PSC Box Beam and PSC Cored Slab Beam Bridges Common Item and Quantity Errors

Example 1 - PSC Box Beam Bridge

BRIDGE SERIAL NO. 145-0052-0
 BRIDGE I.D. NO. 145-01427F-001.78E
 PROJECT P.J. NO. 0015315

BRIDGE NO. 1		GEORGIA	
DEPARTMENT OF TRANSPORTATION			
ENGINEERING DIVISION-OFFICE OF BRIDGES AND STRUCTURES			
PLAN AND ELEVATION			
CR 29 (OLD WEST POINT RD)			
OVER CHATTAHOOCHEE RIVER TRIBUTARY			
HARRIS COUNTY			0015315
SCALE: 1" = 10'-0" (UNLESS OTHERWISE NOTED)		JULY 2017	
DRAWING NO. 35-0001	DESIGNED <u>KNT</u>	CHECKED <u>VMW</u>	REVIEWED <u>DLC/SKG</u>
BRIDGE SHEET 1 OF 13	DRAWN <u>KNT</u>	DESIGN GROUP <u>EJC</u>	APPROVED <u>WMD</u>

DATE		REVISIONS		BY		DESIGNED		CHECKED		REVIEWED	
						KNT		VMW		DLC/SKG	
						KNT		EJC		WMD	
DRAWING NO. 35-0002		BRIDGE SHEET 2 OF 13		NO SCALE		JULY 2017

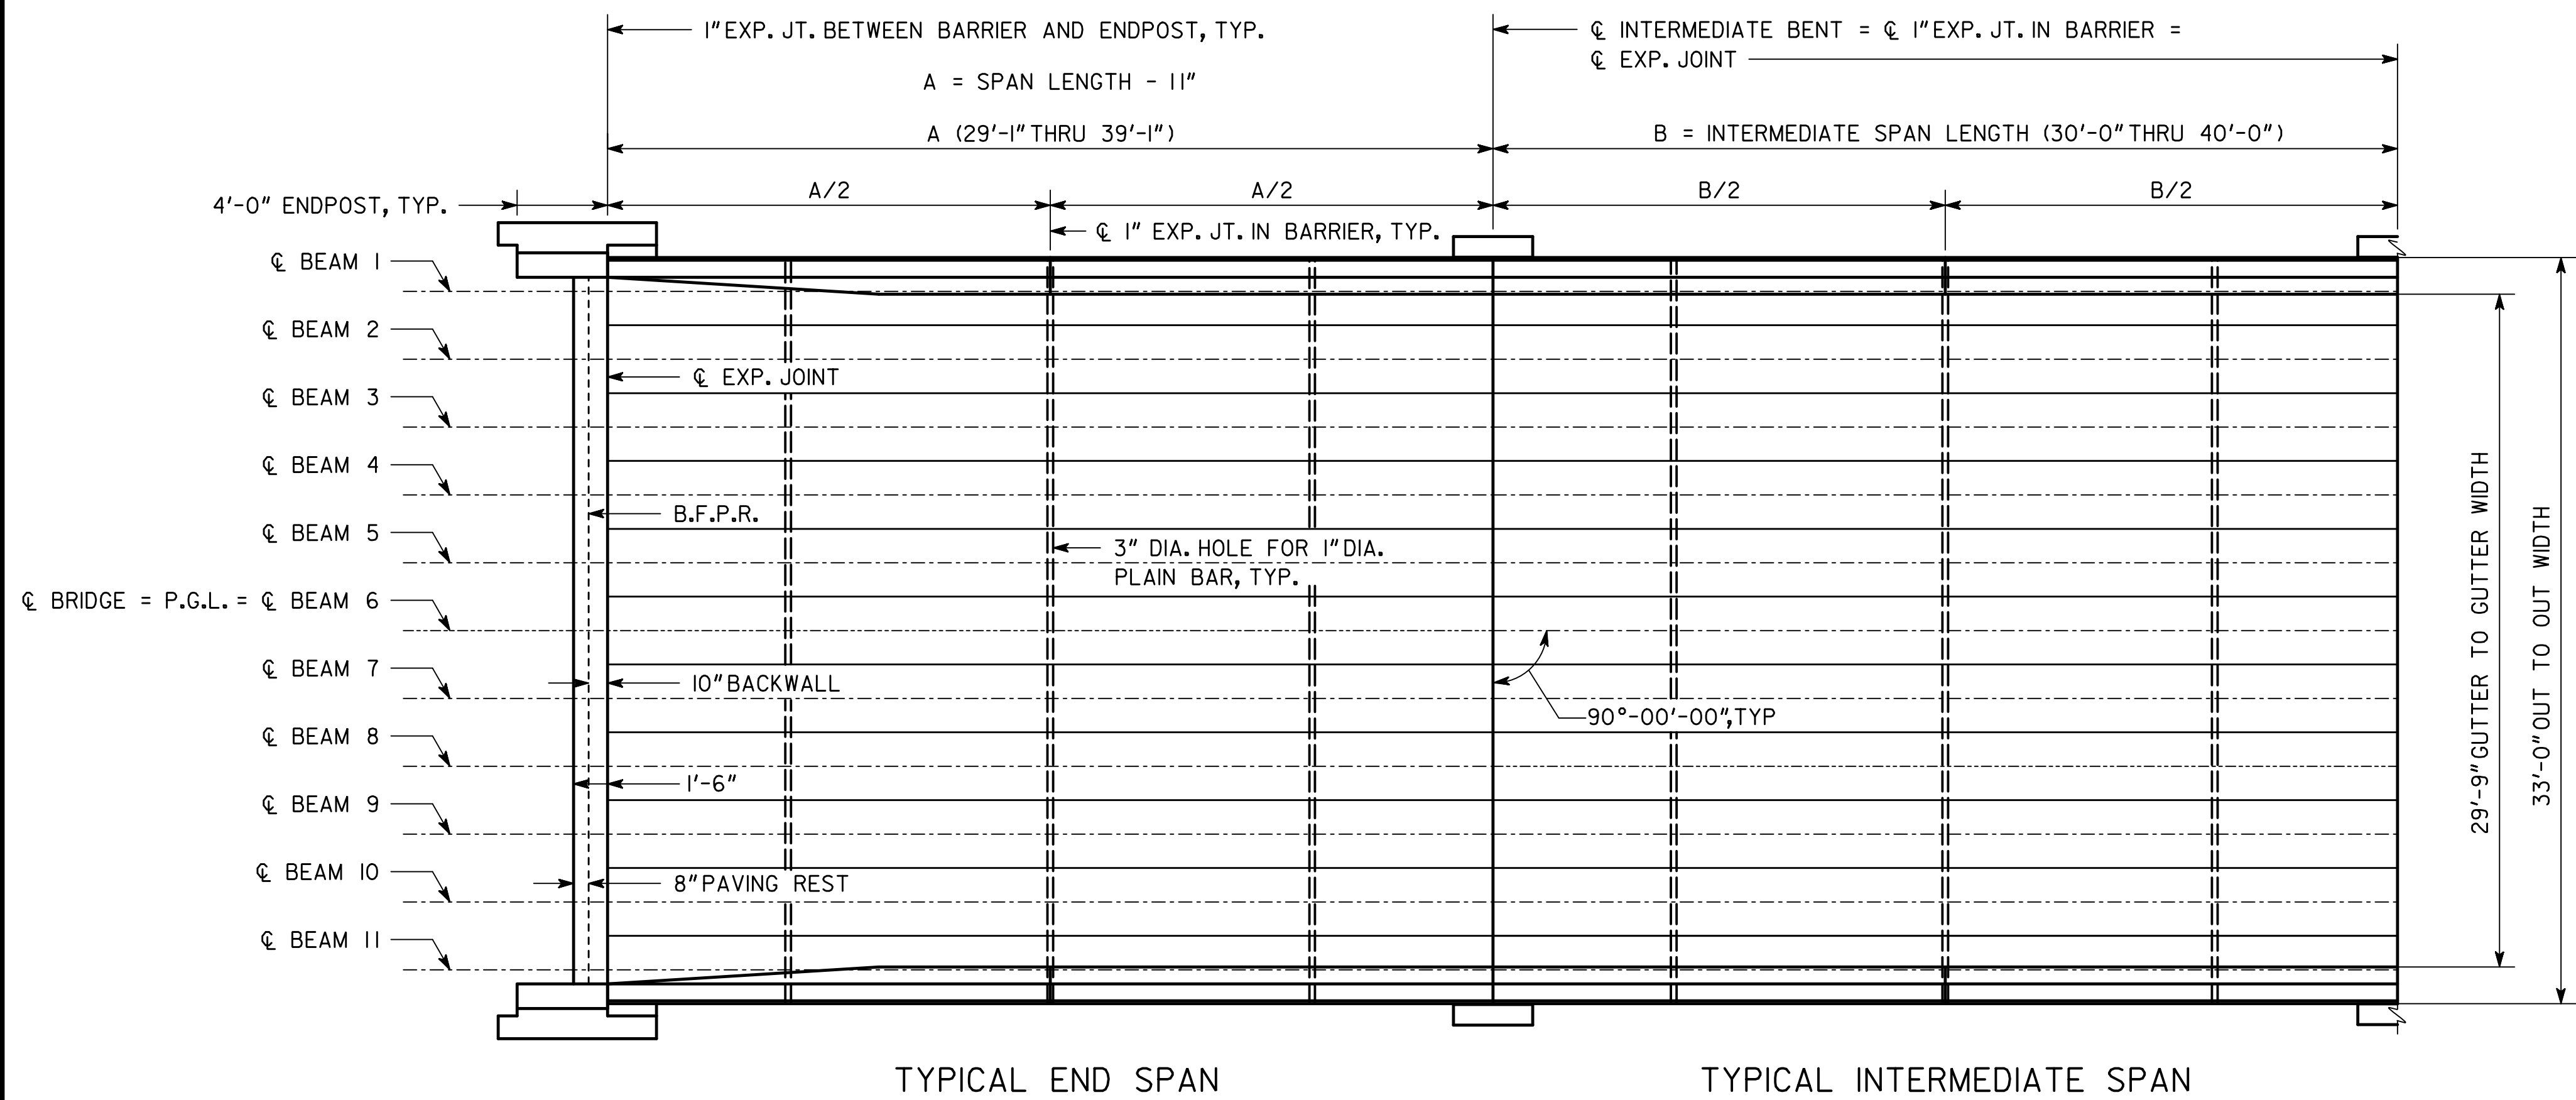
Bridge Quantities Do Not Include the Recycled Asphaltic Concrete or Tack Coat for the Leveling and Overlay of the Bridge Deck

Here Are Clues That The Bridge Deck is Overlaid

DECK PLAN - 29'-9" GUTTER TO GUTTER
30'-0" THRU 40'-0" SPANS
CR 29 (OLD WEST POINT RD)

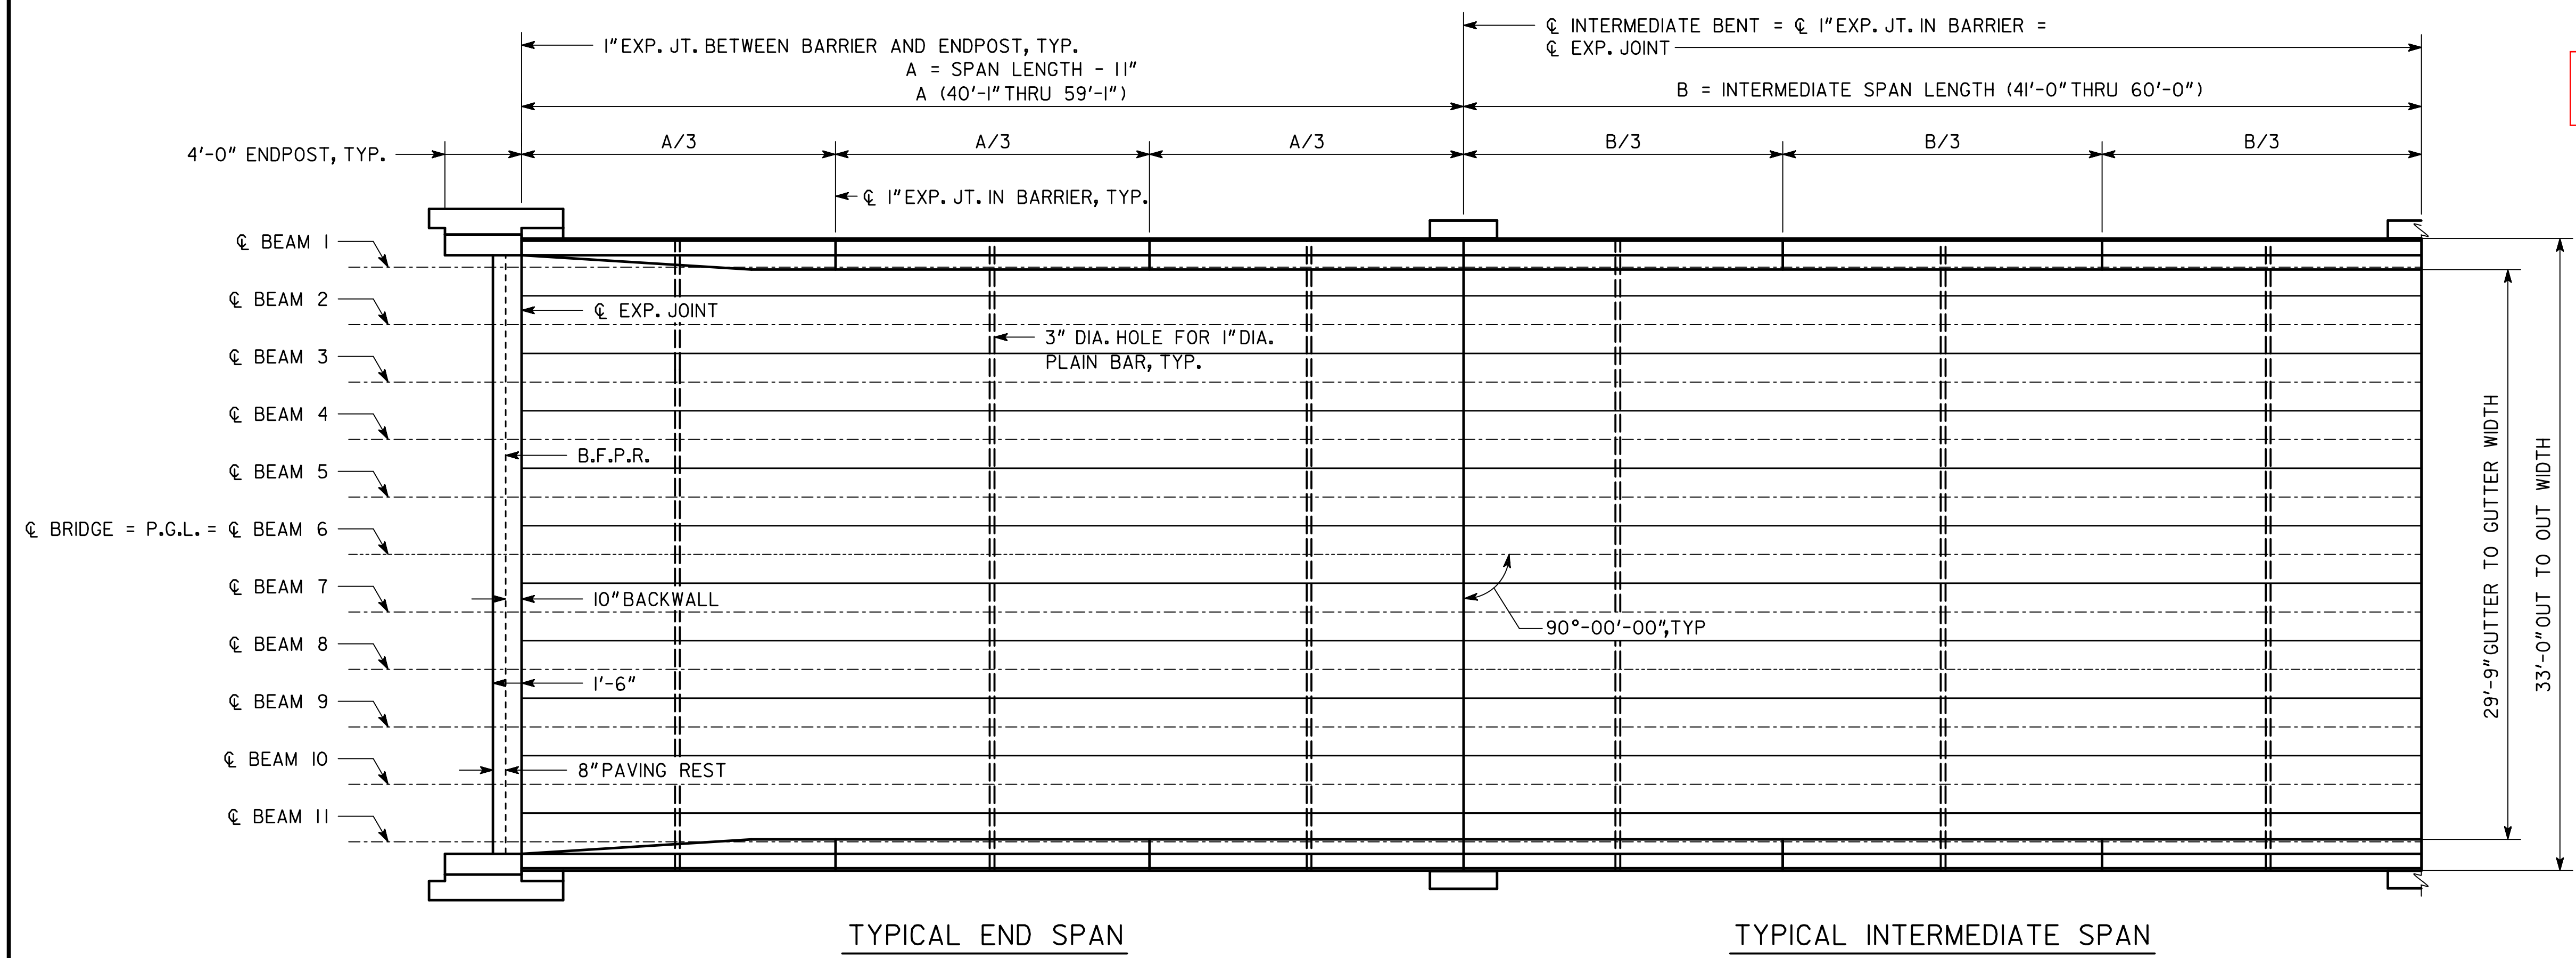
Minimum Overlay Thickness at Gutter Line/Face of Barrier
